Subject: Byron Station Unit 1  
Preservice Inspection  
Relief Requests  
NRC Docket No. 50-454

RELIEF REQUEST NR-9

RELIEF REQUEST NR-10

Figure 1

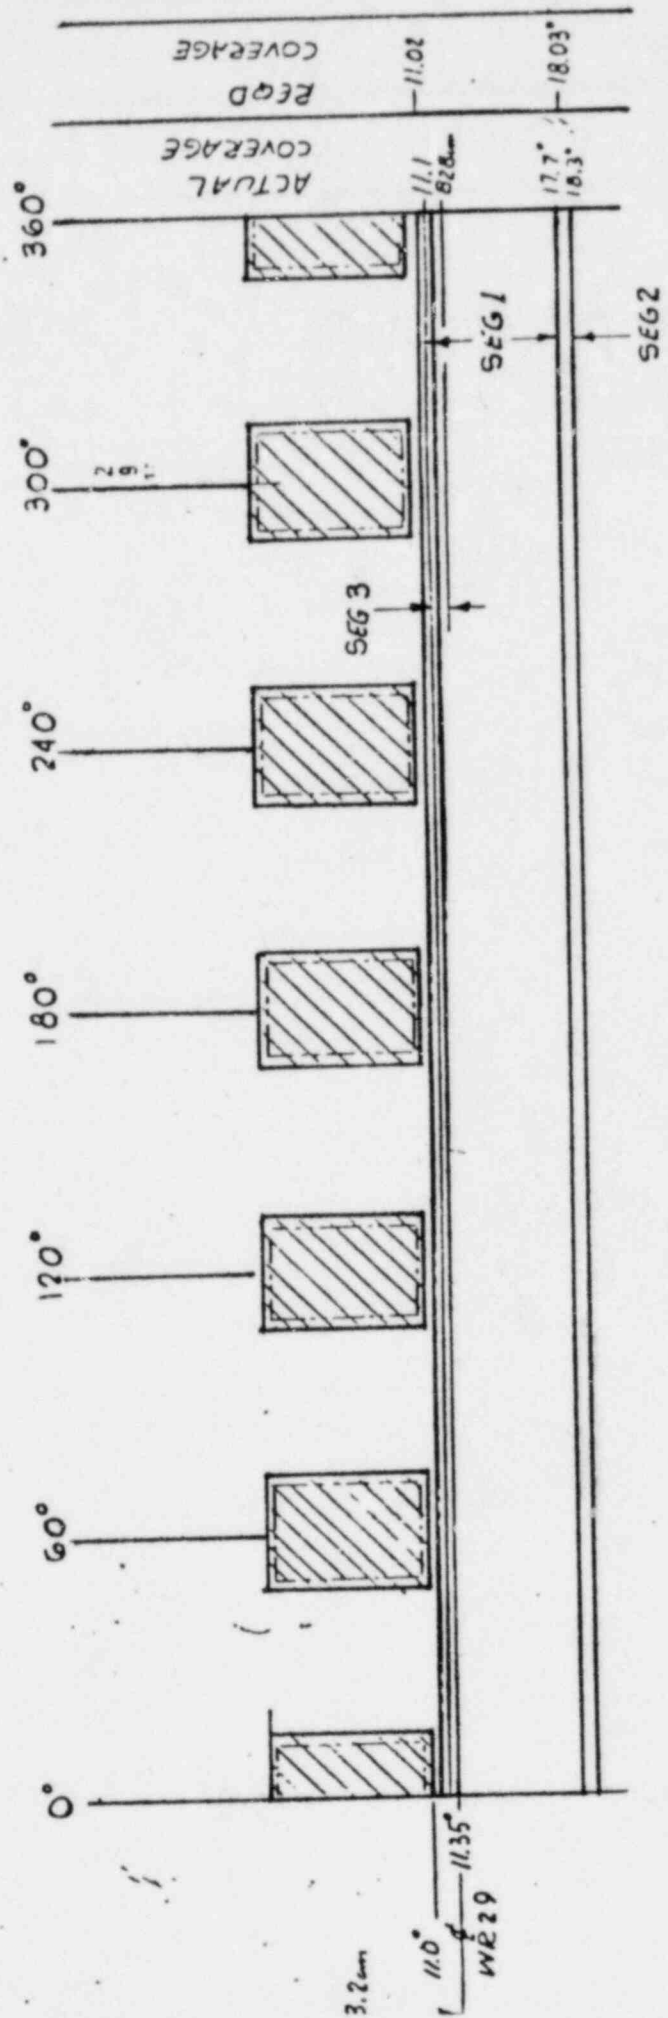
c. Nozzle Shell Course to Reactor Vessel Flange Weld, WR-7 (IWB-2500-4), the reactor vessel flange contains a taper above Weld WR-7 which prevents 100% examination of the adjacent base metal for transverse reflectors from the top side of the weld. However, all the weld metal and 3 inches of adjacent base metal were examined. Attachment NR-9 Figure 1.

NR-9 Attachment #1  
Figure 2

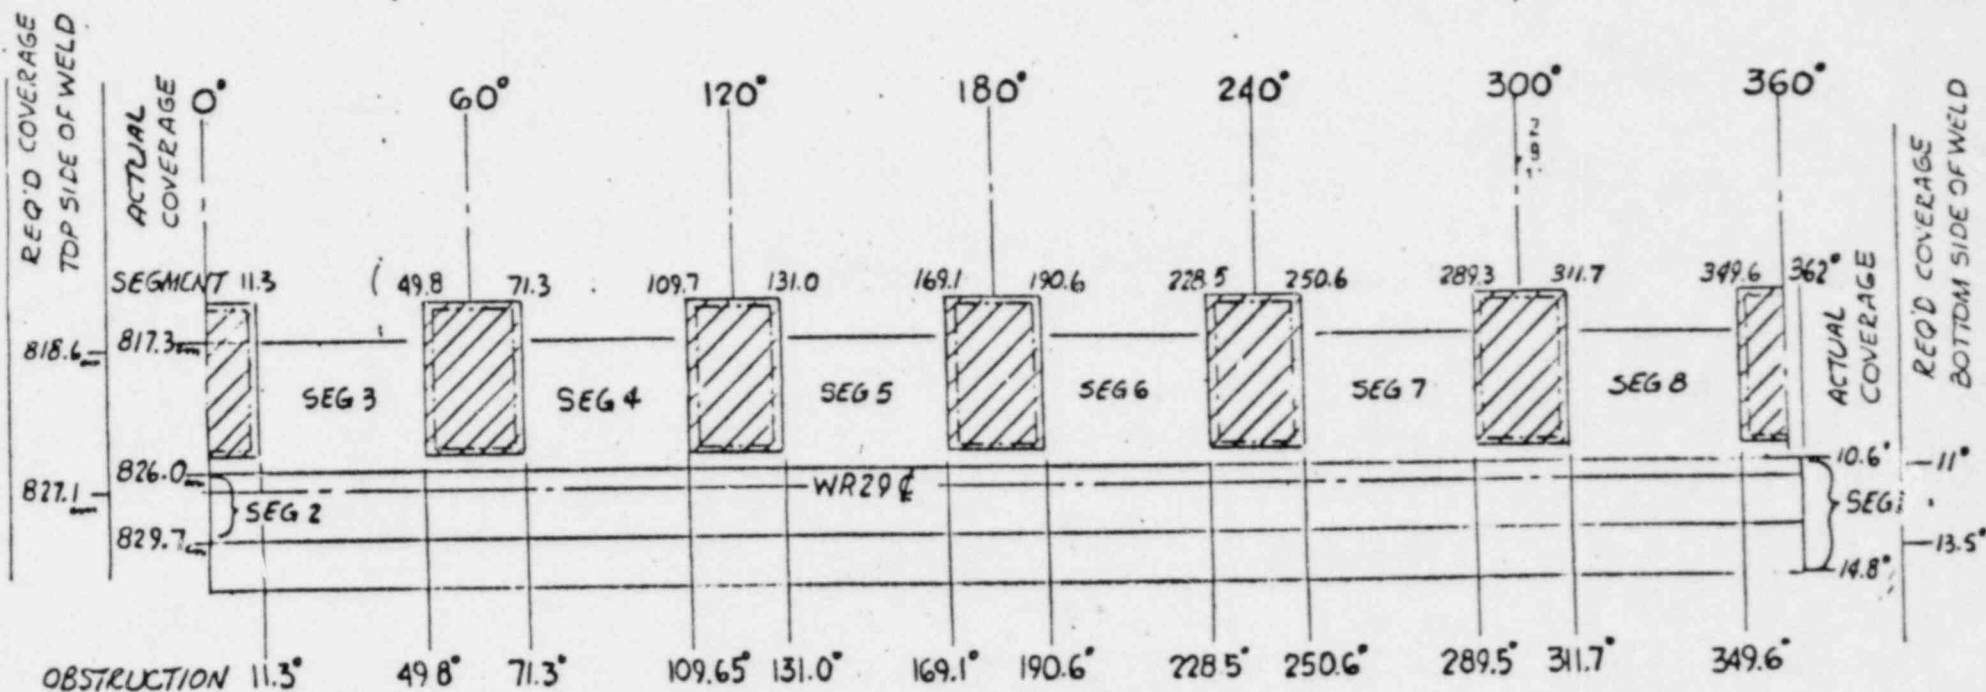
5. BASIS FOR RELIEF:
  - a. Lower Shell Course-to-Dutchman Weld, WR-29, (IWB-2500-1) has six core barrel locating lugs welded to the interior surface of the pressure vessel just above Weld WR-29. The lugs are physical obstructions to the search unit for examinations from the top side of the weld and 100% coverage cannot be achieved. The areas that did not receive 100% examination are shown on Attachment NR-9 Figure 1 through 4.

NR-9 Attachment #1  
 Figure 5

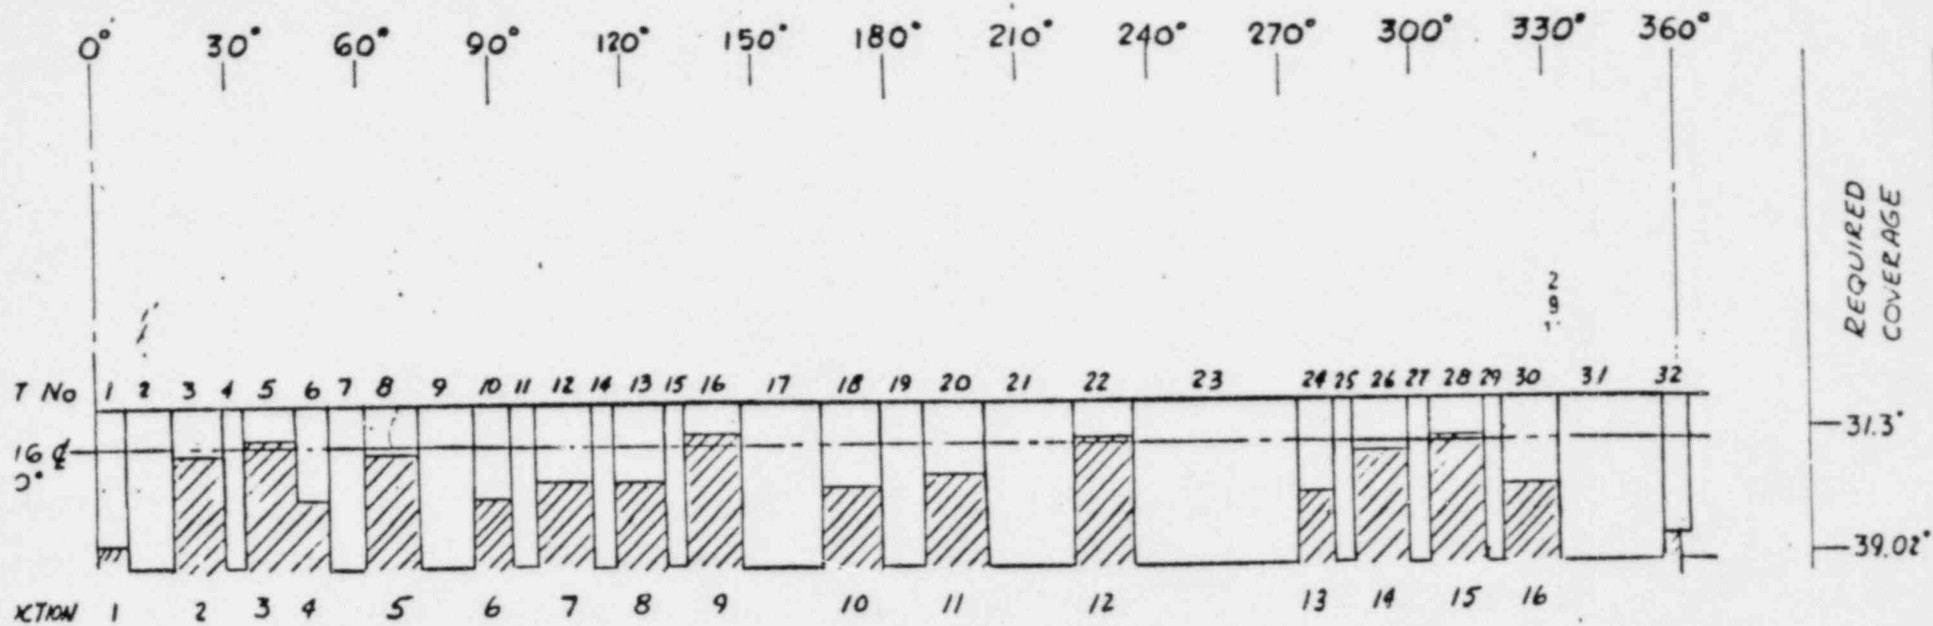
- b. Lower Disk to Dutchman Weld, WR-16 (IWB-2500-3) has instrument tubes that penetrate the lower head physically obstructing the search unit and/or the search unit positioning device which prevents 100% examination. The areas that did not receive 100% examination are shown on Attachment NR-9 Figures 5 through 7.

Figure 1

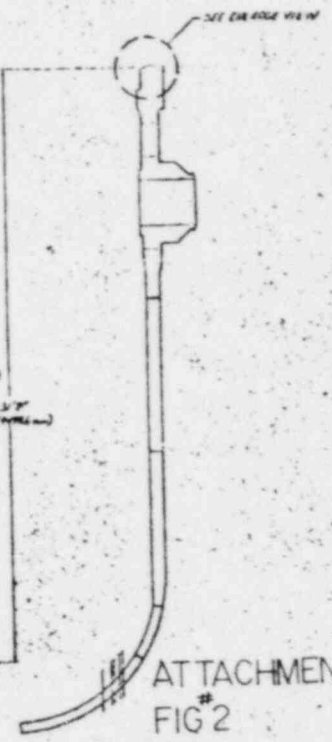
5. BASIS FOR RELIEF: Nozzle to Vessel welds on nozzles A, D, E, and H, the examination for transverse reflectors is performed from the reactor vessel surface. The integral extension on the outlet nozzles is a physical obstruction to the search unit which prevents 100% coverage of adjacent base metal near the nozzle bore. However, all of the weld metal and 4 inches of adjacent base metal were examined. As shown on Attachment 1.
